**PREVOST**

**WARRANTY  
BULLETIN**

Wb98-33

DATE :	October 1998	SECTION :	22, HVAC
EXPIRATION :	October 1999		
SUBJECT :	A/C SYSTEM MODIFICATIONS

**Figure 19:** Rear electrical compartment. (1) R38 relay; (2) 064931 cable; (3) C551 connector; (4) C139 connectors; (5) 2B cable.

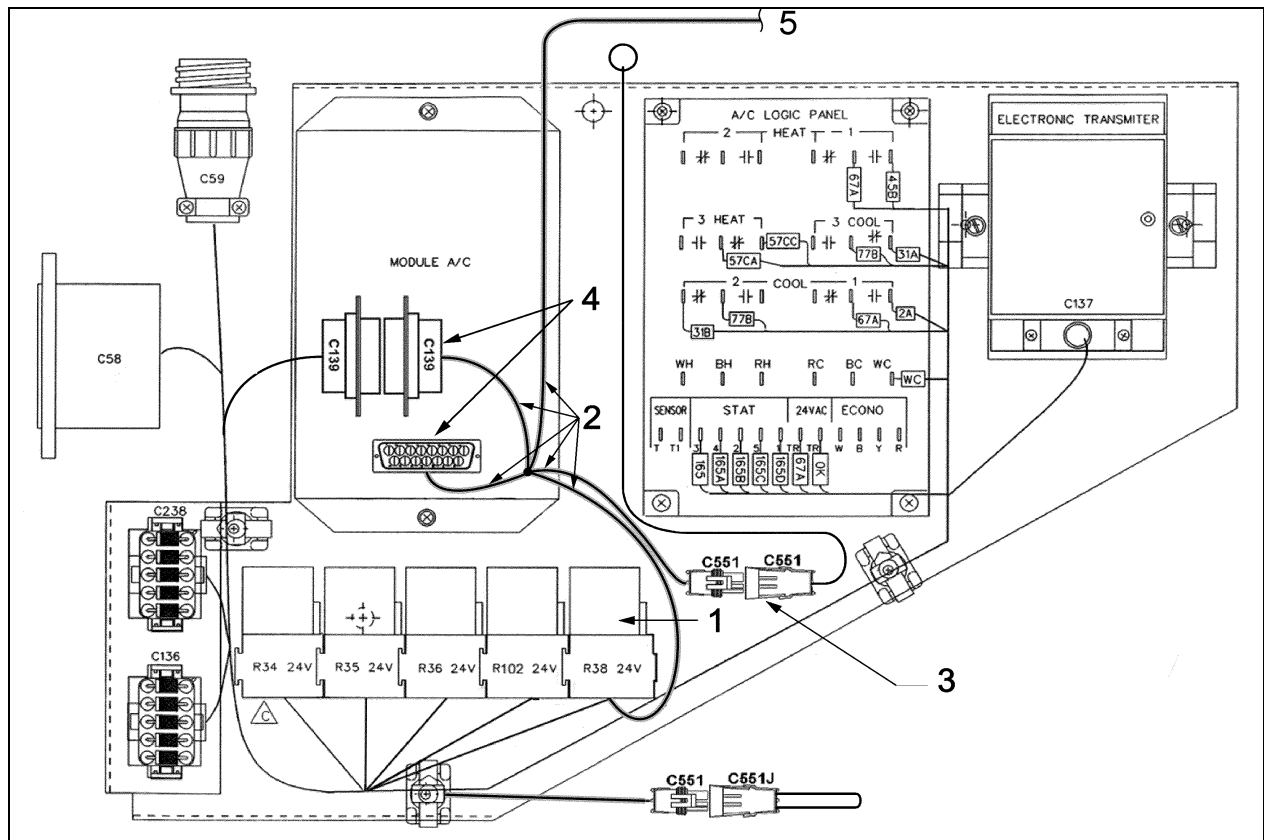
3. Fix new R38 relay base on the A/C junction panel, next to R102 relay for instance. This base belongs to cable 064931 (item 2, figure 19);
4. Fix R38 relay on its base (item 1, figure 19);
5. Remove and discard C551 jumper of 062931 cable. Plug C551 connector belonging to 064931 cable on the C551 connector coming from the thermostat (77A and 77HA wires are coming from thermostat), as shown on figure 19, item 3 ;
6. Plug both C139 connectors pertaining to 064931 cable on the A/C module and on the vehicle's wiring (item 4, figure 19). Use cable ties to secure the connections;
7. Plug 2B cable (item 5, figure 19) on SP92 spare wire. SP92 is located near C52 connector in the rear electrical compartment;

Figure 20: Rear electrical compartment: (1) New R38 relay; (2) 064931 cable; (3) Tie wrap; (4) 2B wire.

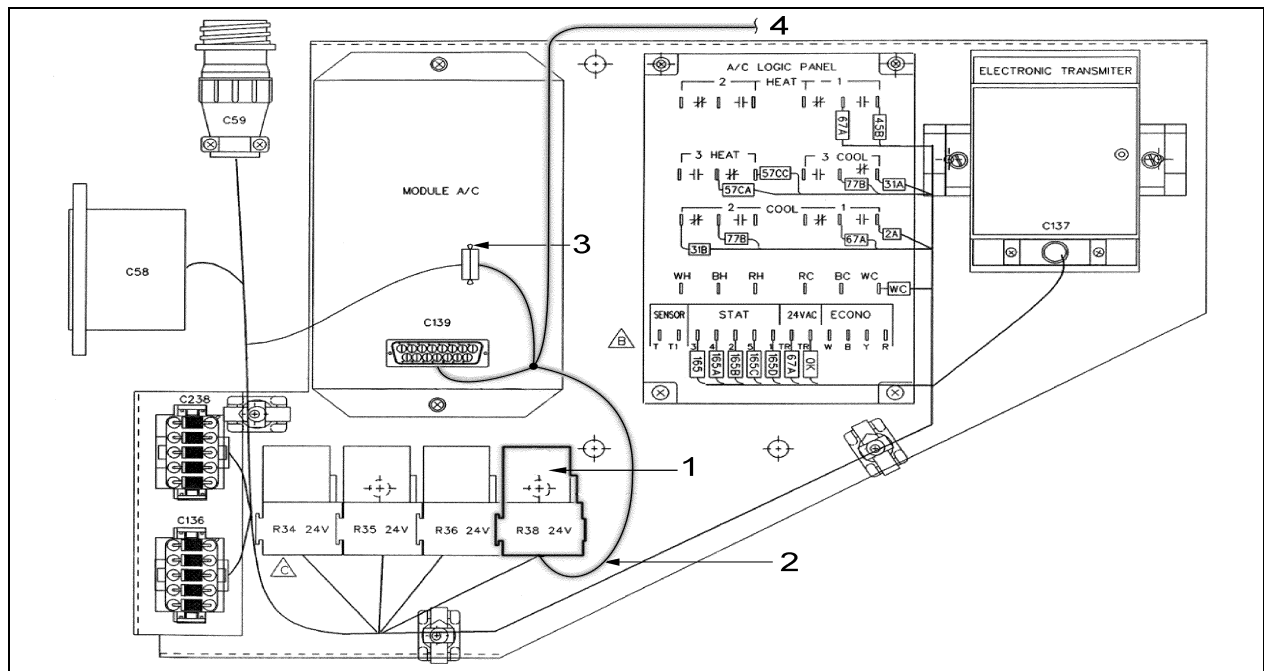
1. Open the rear electrical compartment (figure 14) and locate R36 relay on the front wall of the compartment;
2. Fix new R38 relay base next to R36 relay. This base belongs to cable 064931 (item 2, figure 20);
3. Unplug C139 connector and connect it to 064931 cable's connector. Use 2 cable ties to secure the connection (item 3, figure 20);
4. Plug 064931 cable's proper terminal to the C139 connector located on the A/C module;
5. Identify spare wire SP92 located near C52 connector in the rear electrical compartment. Crimp and heat 2B wire (item 4, figure 20) with SP92 wire;
6. Open the condenser compartment (figure 1);
7. Plug 2B wire (item 1, figure 17) of 064932 cable on SP92 wire then crimp and heat;
8. Connect 0A terminal of 064932 cable on a stud as shown on figure 17, item 3;

**Figure 23:** (1) Capscrew; (2) Cylinder head; (3) Cylinder Head Gasket; (4) Capscrew; (5) Lockwasher; (6) Discharge Valve Stop; (7) Discharge Valve; (8) Valve Plate; (9) Valve Plate Gasket; (10) Suction Valve; (11) Position Spring; (12) Dowel Pin.

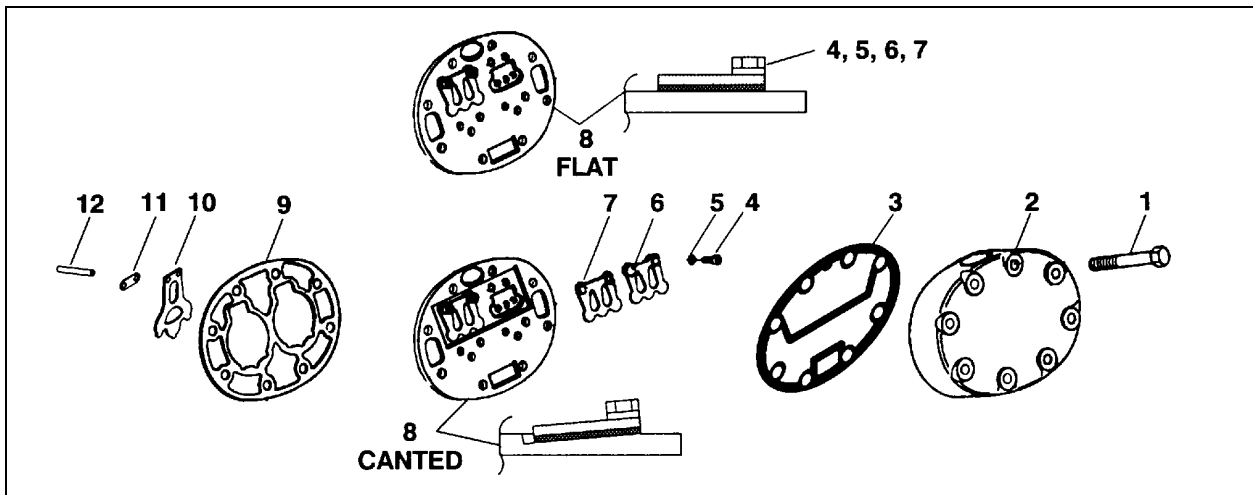
3. Using a 9/16 wrench or socket, loosen the head capscrews (4) a few turns, using a criss-cross pattern. If the head (2) is stuck, tap it lightly with a wooden or lead mallet to free it. Do not remove screws until the head has been unseated from the cylinder deck of compressor, and any pressure that may be contained inside the head has been relieved.

4. If the valve plate (8) did not come loose from the cylinder deck during cylinder head removal, the following procedure should be used:

- Free the valve plates (8) from the cylinder deck by using the discharge valve capscrews, without washers, as jackscrews through the outermost tapped holes in the valve plate after the valve stops (6) and valves (7) have been removed. Remove the valve plate gasket (9).

5. Install the new suction valves (10) and valve plates (8). The side heads should have 4 dowel pins for positioning of the suction valves. Place the new suction valve springs on dowel pins and springs, with the springs bowing upward (see figure 24). Place a new gasket (9) and valve plate (8) onto the cylinder deck over the suction valves (10) and aligned with dowels pins (12).

6. Once the valve plates (8) are in place, position the new head gaskets (3) and heads (2) onto valve plates (8) and install the capscrews (1). Using a criss-cross pattern, tighten the head bolts from the center to outside of each head. The final torque value for bolts is 40 to 50 ft-lb. This torque should be obtained by stepping up the value in two separate sequences. (Example: 25 ft-lb the first sequence, then 40-50 ft-lb on the second sequence).

**Figure 26:** (1) Thermostat support; (2) Connector to remove; (3) Thermostat to remove.

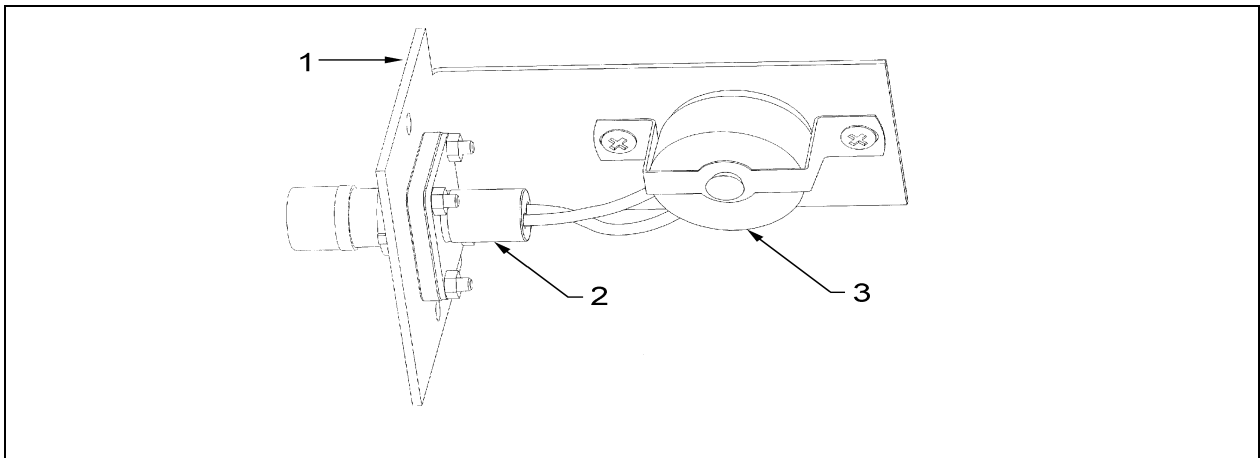
3. Unplug C550 connector;
4. Unscrew the thermostat support (item 1, figure 26) and remove the connector (item 2, figure 26) and the thermostat (item 3, figure 26) ;
5. Install new thermostat assembly (figure 27);
6. Fix the thermostat support on the air intake duct;
7. Plug C550 connector.
